**CONKLIN LANDFILL  
FOLLOW-UP REPORT  
TO  
5-YEAR USEPA REVIEW**

For the:  
Former Conklin Landfill  
EPA ID NYD981486947  
Broome Parkway  
Town of Conklin  
Broome County, New York

SCE Project No. R08126.00

August 2008

DRAWING TITLE **JULY 2008 GROUNDWATER POTENTIOMETRIC MAP**

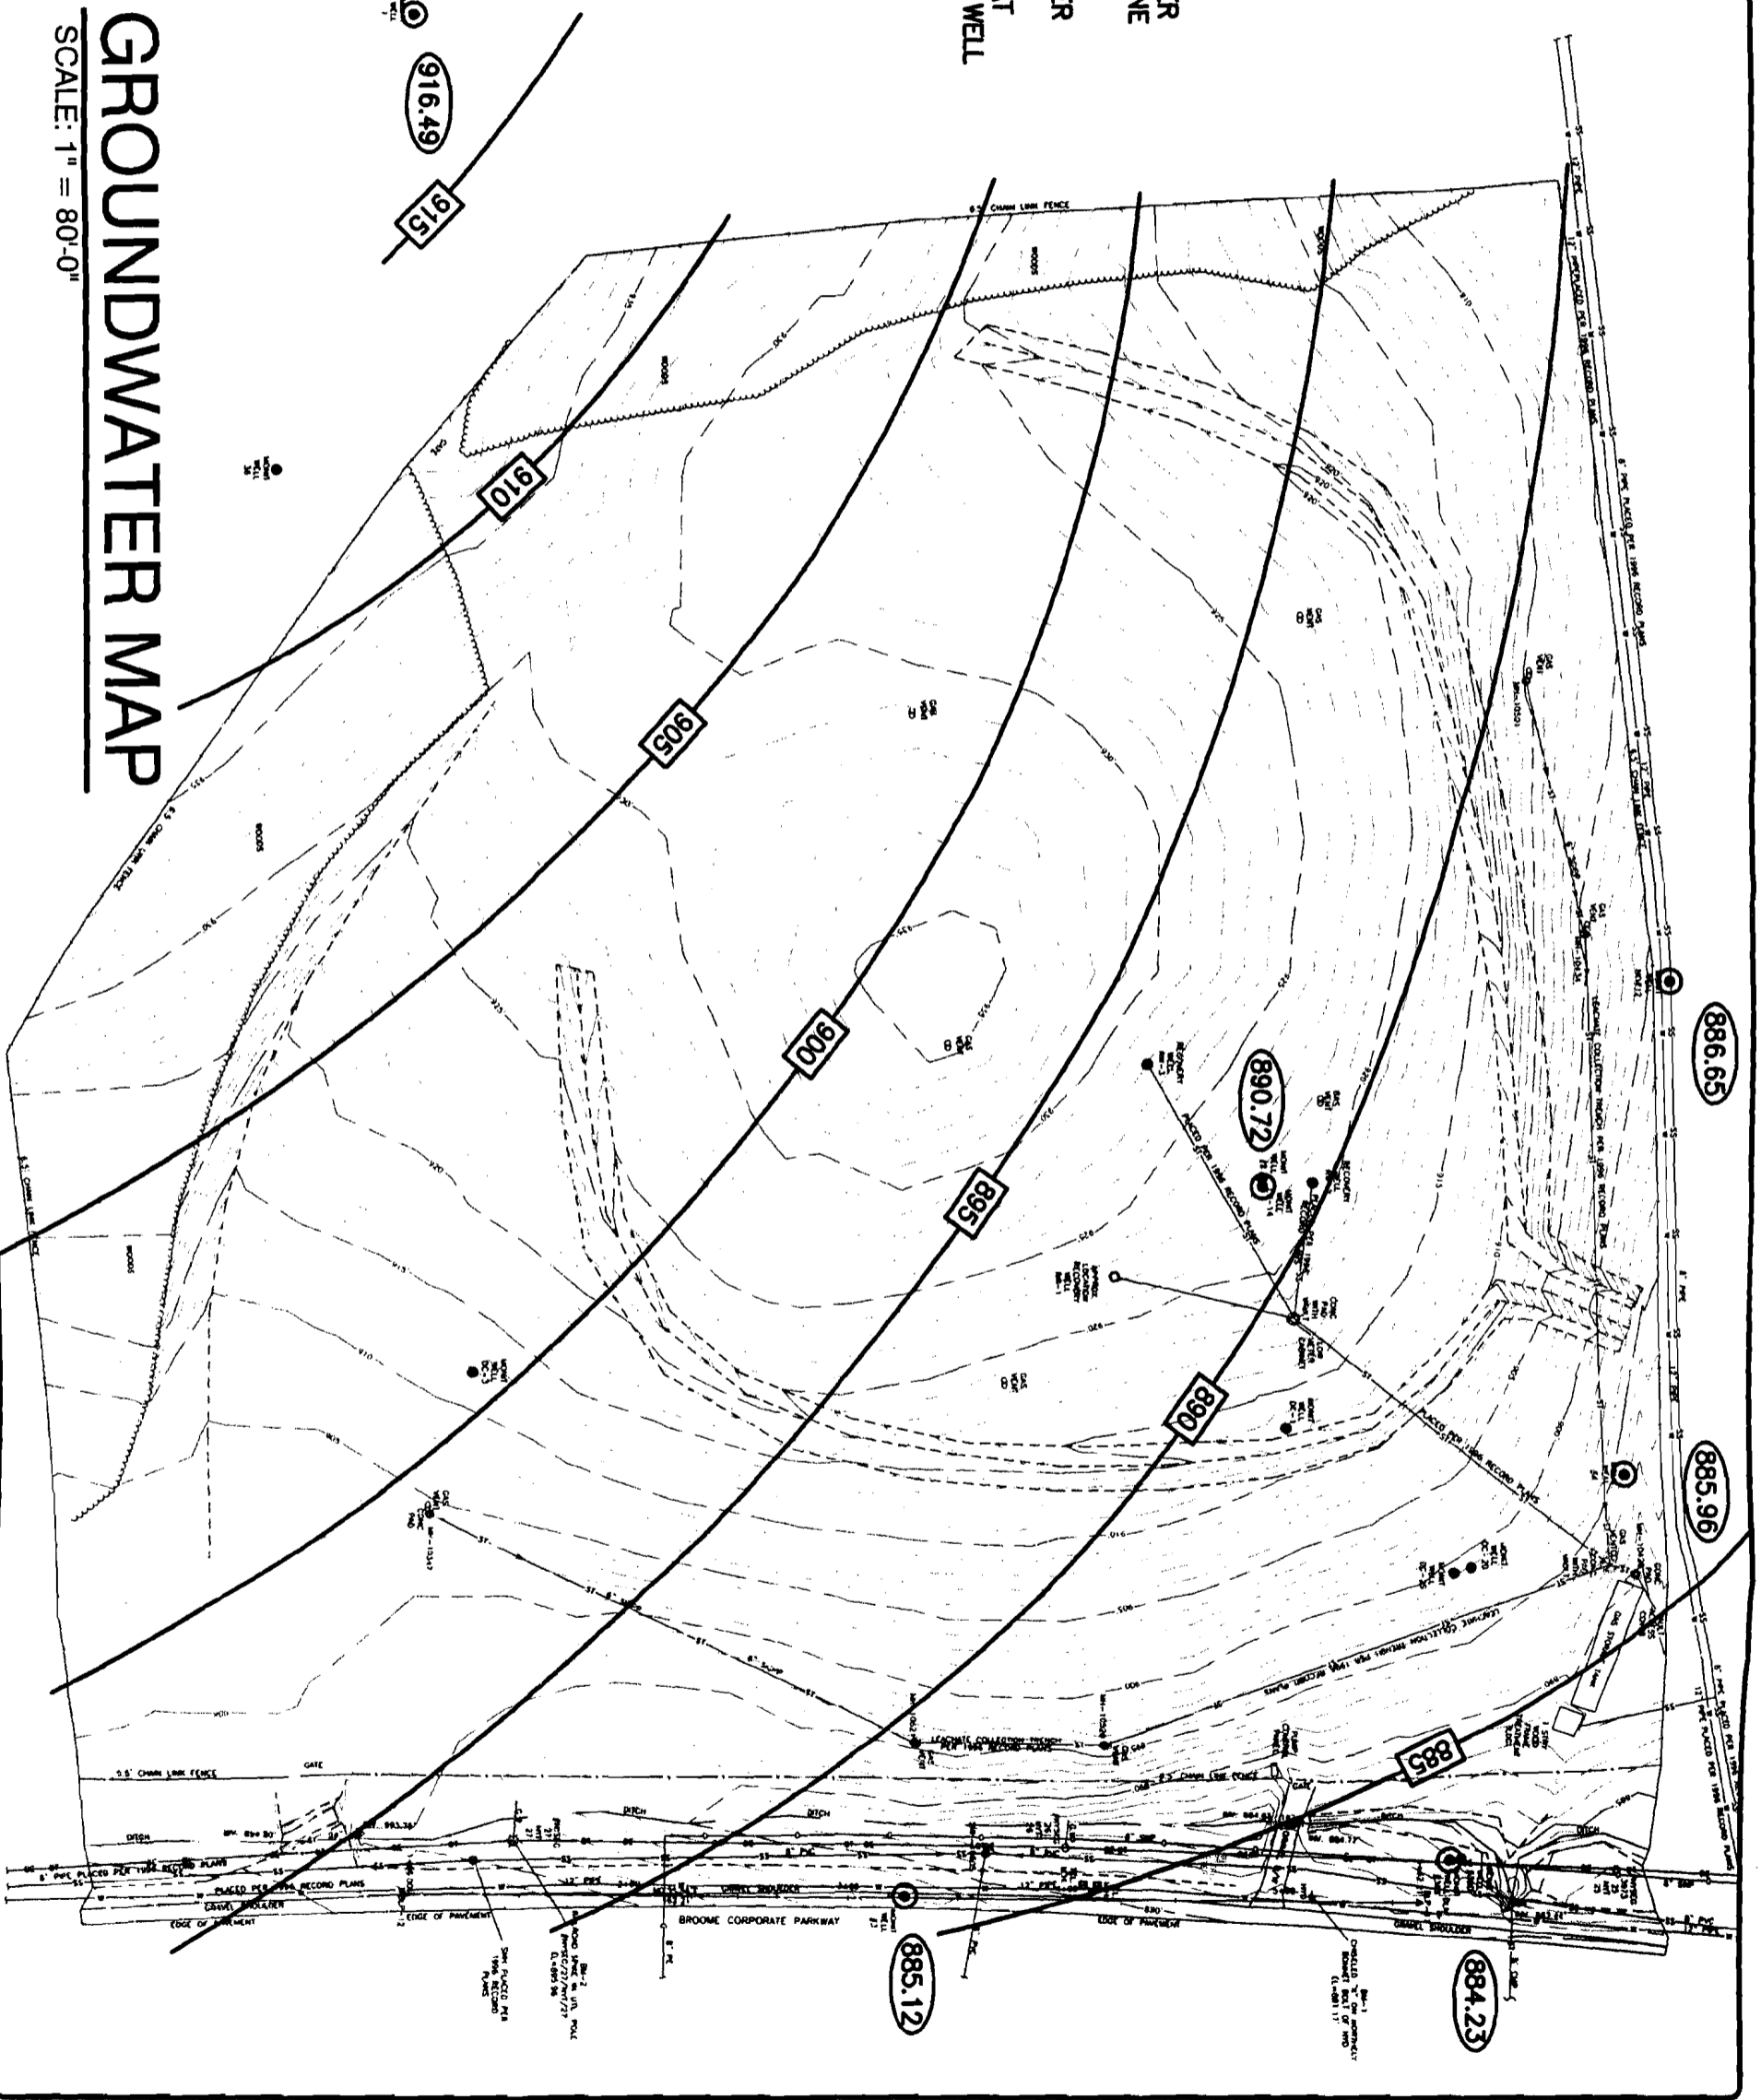
**3.4.3 SUGGESTION:** "For each future sampling event, the water levels should be measured and potentiometric maps should be created. Contouring the water table to establish actual flow directions will require taking water level measurements from old wells that have not been included in the past. Since landfill compaction has the potential to damage the inner casing, the older wells will require an evaluation."

**RESPONSE:** Utilizing data collected during the July, 2008 investigation and new survey, SCE has created a baseline groundwater flow map. This map is included as **Figure 4** herein. It is important to note that the leachate collection system was not

operational during this study, and the groundwater contours depicted on Figure 4 are likely natural contours. With follow-on monitoring events, it is recommended that a groundwater flow map be determined so that the actual potentiometric maps will reflect drawdown caused by the leachate collection system.
